STAFF REPORT AND RECOMMENDATION TO THE DESIGN COMMISSION

CASE FILE: LU 13-192030 DZM
PC # 13-111743
Burnside Bridgehead Block 67
REVIEW BY: Design Commission
WHEN: November 21, 2013 at 1:30 PM
WHERE: 1900 SW Fourth Ave., Room 2500A
Portland, OR 97201

Design Review for a mixed-use 206' tall building; 16 stories of apartments (276 units) over 5 story podium with retail and office space (19,709 SF) and parking garage with 200 spaces. An alternative design is proposed for a tower of similar height (195') but less stories and residential units; 13 stories of apartment (222 units) over 5 story podium (same amount of retail and parking spaces). The 32,470 SF block is exceeding the 9:1 allowed FAR by utilizing the residential floor area bonus allowed per Section 33.510.210.C for up to an additional 3:1 FAR. The total FAR for both designs has yet been finalized but is assumed to be less than the 12:1 allowed.

Site Plan Key
Scale: 1" = 30' 0"

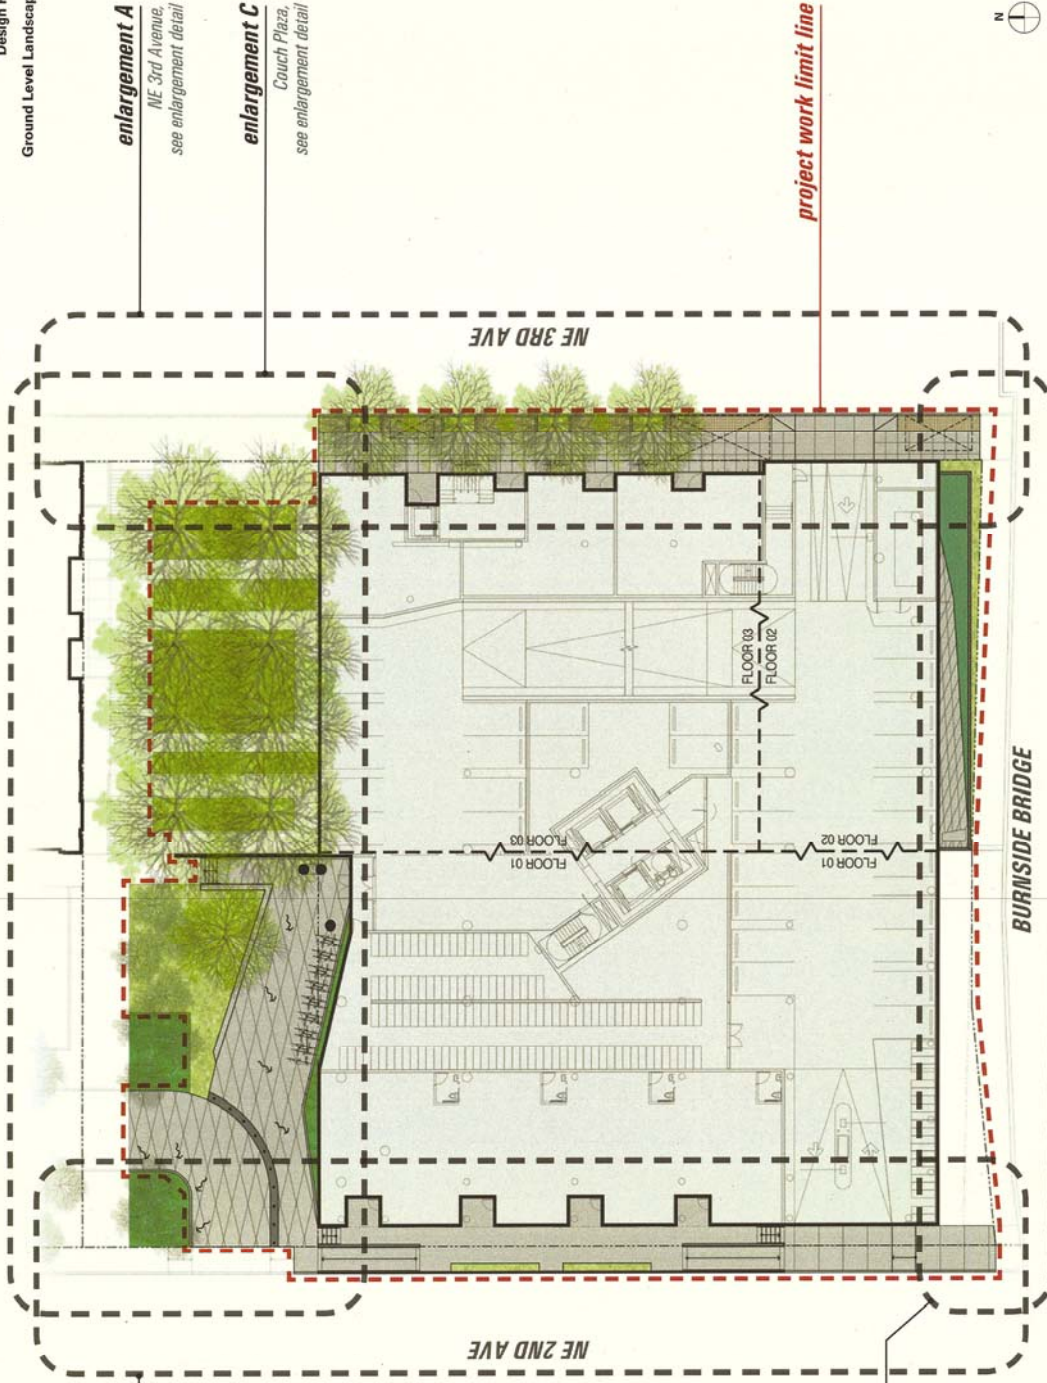
- Remove "Sidewalk Easement" reference on site plan (Exhibit C-11) since no easement is required.
- Alternate design for 18 story tower should be more clearly distinguished in the plans. Renderings should also be provided.
